Planning Applications and Related Development Control Matters

AMENDMENT REPORT

APPLICATION No: 19/74484/REM
APPLICANT: C/O Agent
LOCATION: Land To The West Of , Michigan Avenue, Salford, M50 2GY ,
PROPOSAL: Details of reserved matters for access, appearance, landscaping, layout and scale for a residential-led development comprising of 1,298 apartments and 16 townhouses (use class C3) and 1423sqm of commercial floor space (use classes A1, A2, A3, A4, A5, B1, D1 and D2) with associated works, pursuant to outline planning permission 18/72756/OUT
WARD: Ordsall

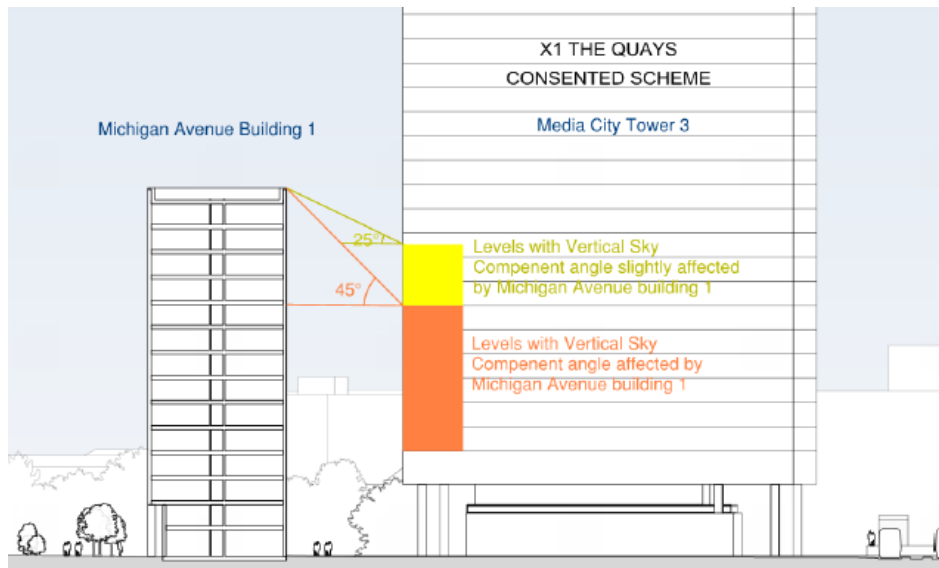
The image below is taken from the daylight report submitted and shows the relationship between the two buildings and the level of apartments which are impacted on the VSC angle.

This exercise shows that the development will have an impact upon the daylight received into 12 apartments across towers 3 and 4, shown orange above. In respect of the apartments with a VSC which sits between 25 and 45 degrees, shown yellow, these apartments benefit from large windows and building 1 in the proposed development is largely glazed. The report concludes, for these reasons that the yellow shaded apartments will have access to sufficient daylight. It is acknowledged that the apartments in question do not benefit from high levels of sunlight due to their orientation north.

No before and after ADF figures have been provided in respect of towers 3 and 4. However, the impacts are clear from the VSC information that the development will have a detrimental impact directly on the daylight received into 12 apartments within towers 3 and 4. This equates to 2% of the 550 apartments within towers 3 and 4. Given the low level of apartments impacted upon, being mindful of the urban context and the suitability of the site for high density development and that the layout of building 1 has been positioned to accommodate Michigan Walk, the benefits of the scheme clearly outweigh the amenity impacts on neighbouring future occupiers and as such no objections are raised to the development in this regard.
